**CONESTOGA-ROVERS
& ASSOCIATES**

Re: **Soil Boring Workplan**
Former Texaco Service Station (Chevron Site # 307233)
2259 First Street
Livermore, CA
RO #2908

Subject: Fuel Leak Case No. RO0002908 and Geotracker Global ID T0600196622, Miller Square Park, 2259 First Street, Livermore, CA 94550

figure 3
 SITE PLAN WITH PROPOSED BORING LOCATIONS
 FORMER CHEVRON STATION 30-7233
 2259 FIRST STREET
 Livermore, California

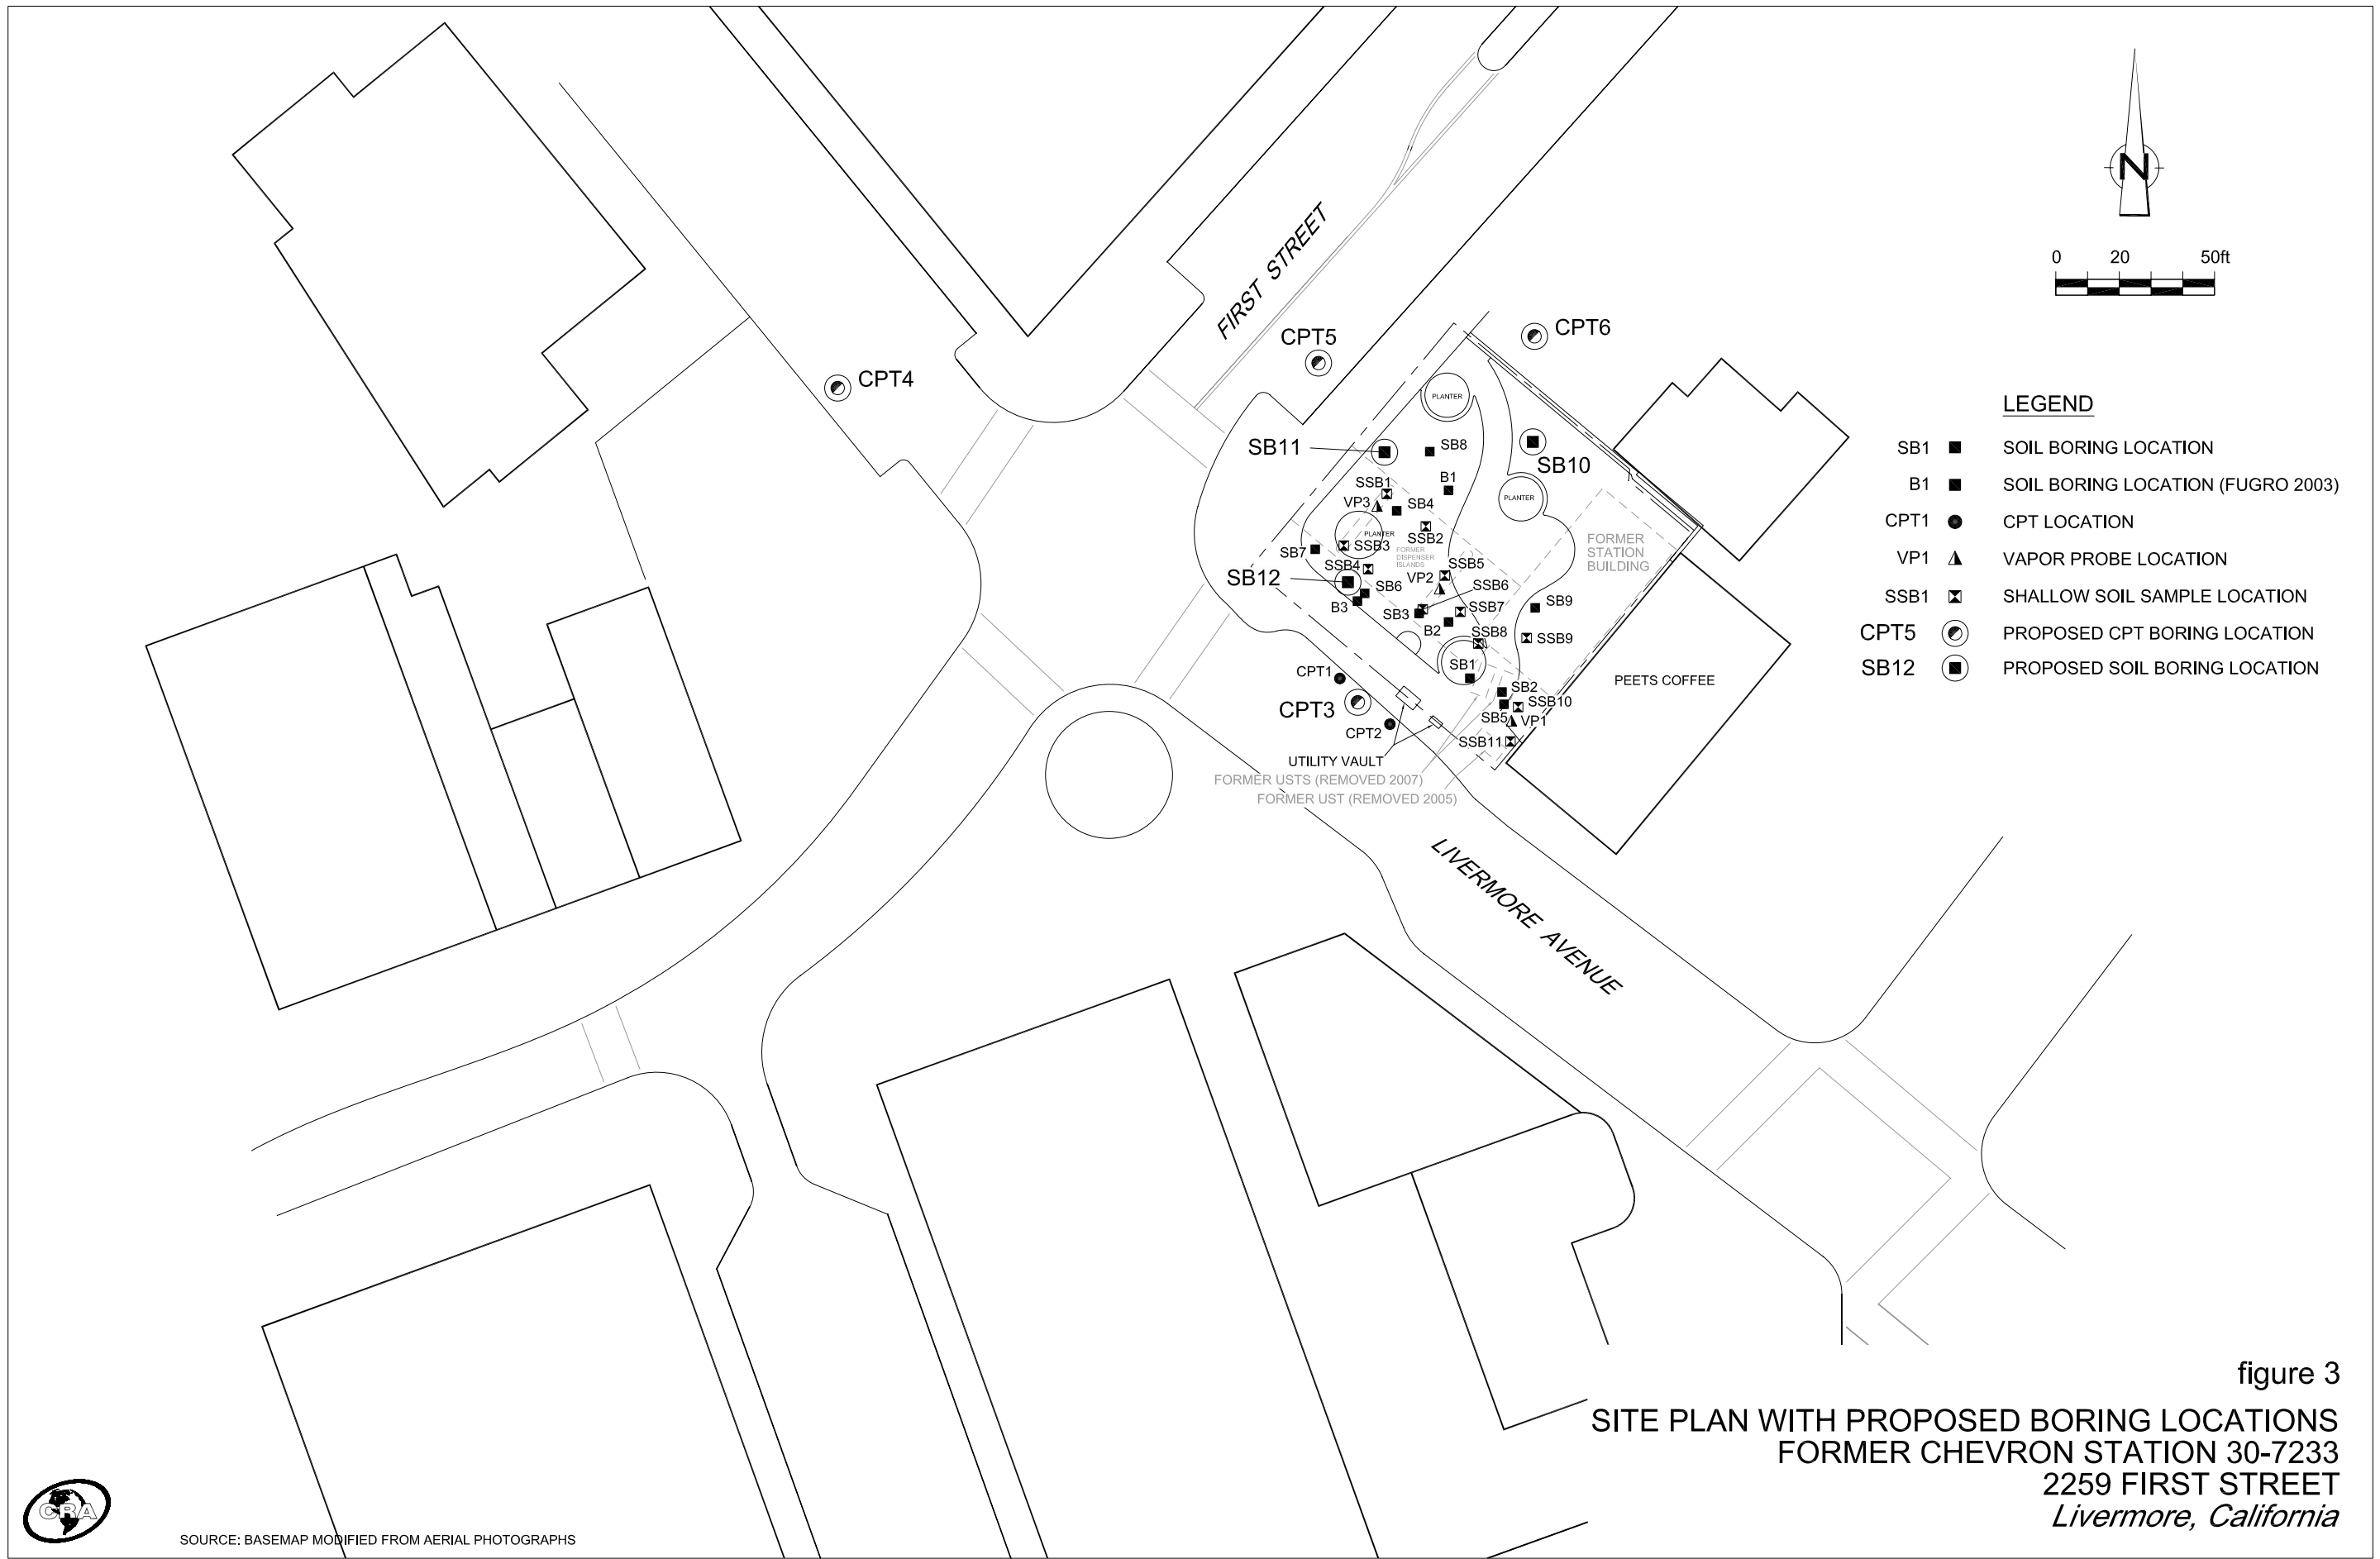
3. **Contamination in Area of SB8.** Soil boring SB8 is located northeast of the former dispenser islands and north of the former USTs. Based on water level data from other sites, the hydraulic gradient in this area of Livermore is to the west to northwest. Therefore, boring SB8 is apparently cross gradient from the suspected sources of fuel releases at the site. However, the concentrations of total petroleum hydrocarbons as gasoline and diesel detected in the grab groundwater sample from SB8 were higher than the concentrations of TPHg and TPHd detected in grab groundwater samples from the other soil borings and cone penetrometer borings advanced in suspected source areas or downgradient from source areas. Please review these data to develop a proposed scope of work to assess whether contamination in the area of boring SB8 is from the suspected sources located in cross gradient directions or whether a contaminant source exists within the area of or upgradient from boring SB8. Please present your analysis and proposed scope of work in the Work Plan requested below.

4. **Vertical Extent of Contamination and CPT Borings.** The cone penetrometer (CPT) borings were stopped at approximately 55 feet bgs rather than the planned 80 feet bgs. The purpose of the CPT borings was to define the vertical extent of contamination. Fuel hydrocarbons were detected at elevated concentrations in the grab groundwater samples collected from first-encountered groundwater in the CPT borings. Based on these results, it is necessary to extend the CPT borings to a depth of 80 feet bgs to define the vertical extent of contamination. Groundwater samples are to be collected from each significant water-bearing zone identified on the CPT log below first encountered groundwater. Please include plans to extend the CPT borings in the Work Plan requested below.

CRA proposes to further delineate the plume horizontally and vertically prior to installing groundwater monitoring wells. To meet this objective, CRA will advance four cone penetration testing (CPT) borings off-site (Figure 3). Borings CPT3 and CPT4 will be advanced down-gradient of the USTs removed in 2005 and 2007, CPT5 will be down-gradient of the potential later generation UST pit, and CPT6 will be cross-gradient of the site. Due to drilling equipment size and safety concerns, all borings will be advanced within parking lanes and not in any through traffic lanes.

CRA also proposes to advance three soil borings within the park (Figure 3). Borings SB10 and SB11 will be drilled using a hollow stem auger near previously sampled boring SB8 to assess whether there is an additional hydrocarbon source in the northern corner of the site. Boring SB12 will be drilled in the vicinity of CRA boring

figure 5
 CROSS SECTION B-B'
 FORMER CHEVRON STATION 30-7233
 2259 FIRST STREET
 Livermore, California

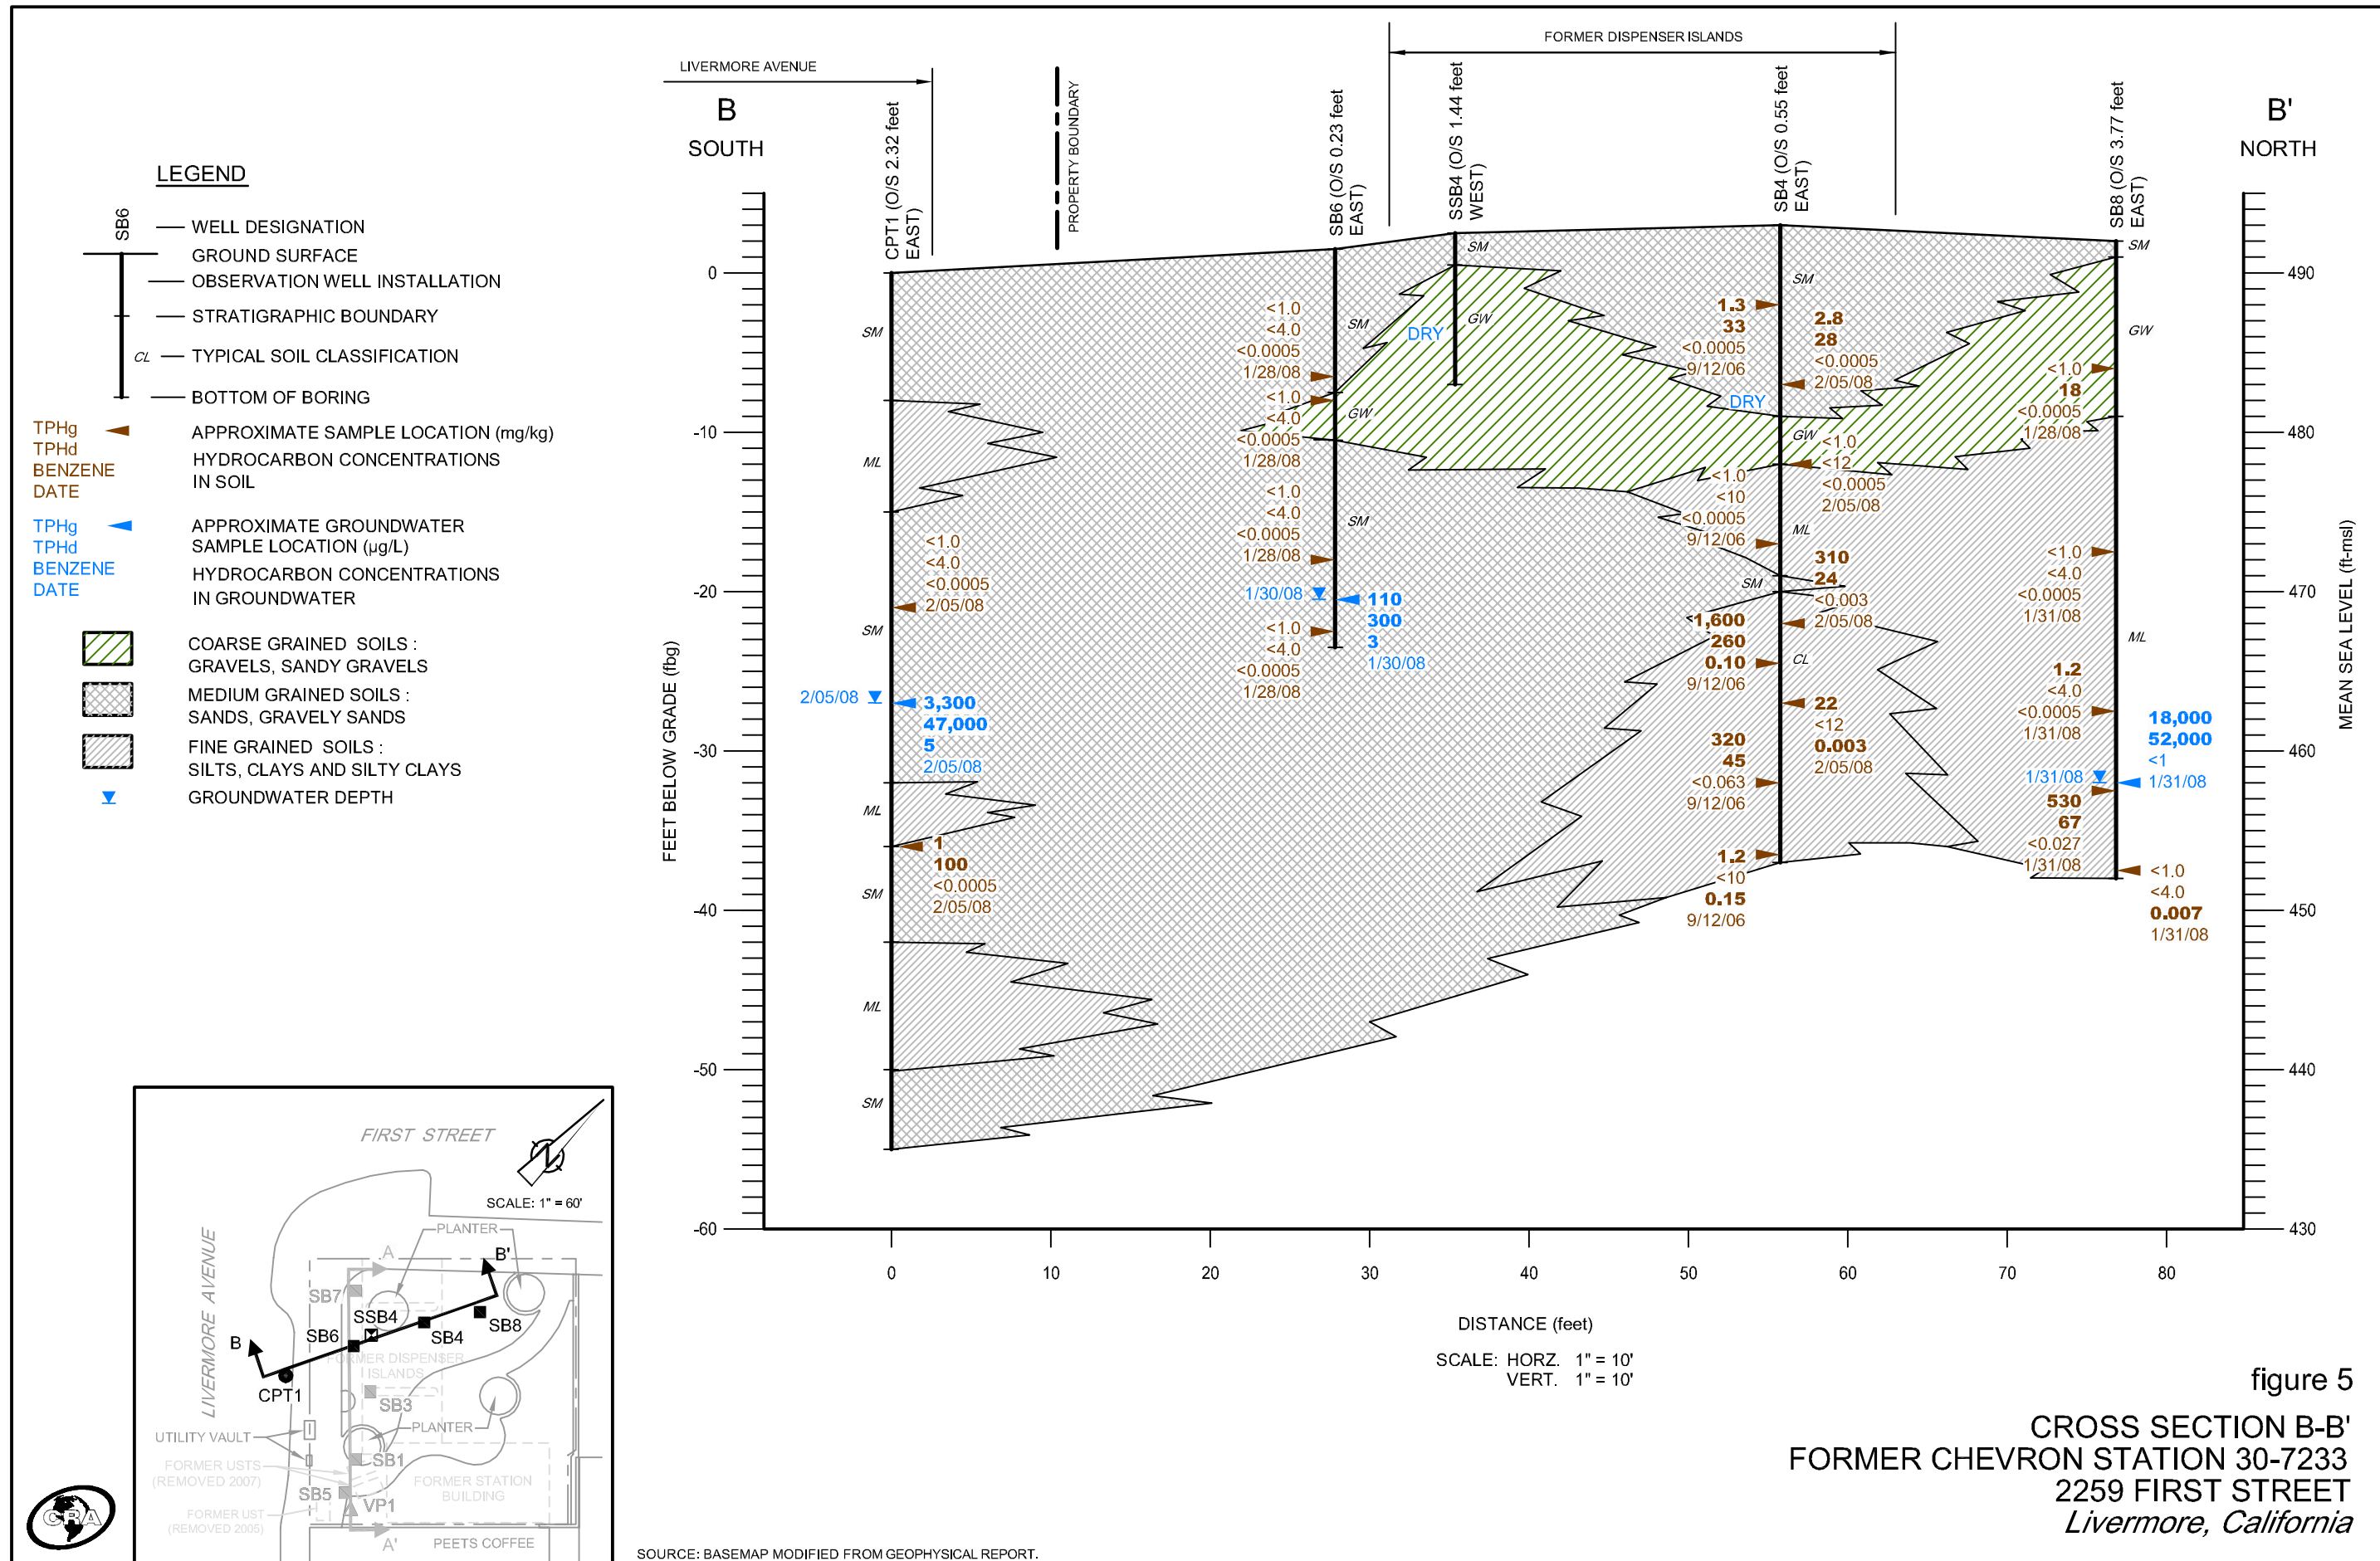
6. **Grab Groundwater Sample from SB6.** The grab groundwater sampling results from soil boring SB6 appear anomalous. Soil boring SB6 was advanced adjacent to boring B3. Boring B3 was advanced by Fugro West, Inc. in September 2003. The grab groundwater sample from SB6 contained TPHg at a concentration of 110 milligrams per kilogram while the grab groundwater sample from Fugro West, Inc. contained TPHg at a concentration of 18,000 mg/kg. The depth to first encountered groundwater in boring SB6 is reported as 22 feet bgs, which is significantly less than the depth to groundwater elsewhere at the site. Furthermore, we are not aware of groundwater being encountered at depths as shallow as 22 feet bgs in this area of Livermore during the January to February 2008 time period. In the Work Plan requested below, please discuss the likely source of shallow groundwater in SB6 and whether the sample is representative. Cross sections of the site are required in order to help in this evaluation.

SB6 (2008) and Fugro boring B-3 (2003) to confirm the depth of first encountered groundwater and previous groundwater sampling results. Cross-sections A-A' and B-B' (Figures 4 and 5), show no perched water zone in this area that would account for a shallower groundwater depth in boring SB6 as compared to the depth of groundwater encountered in all other borings.
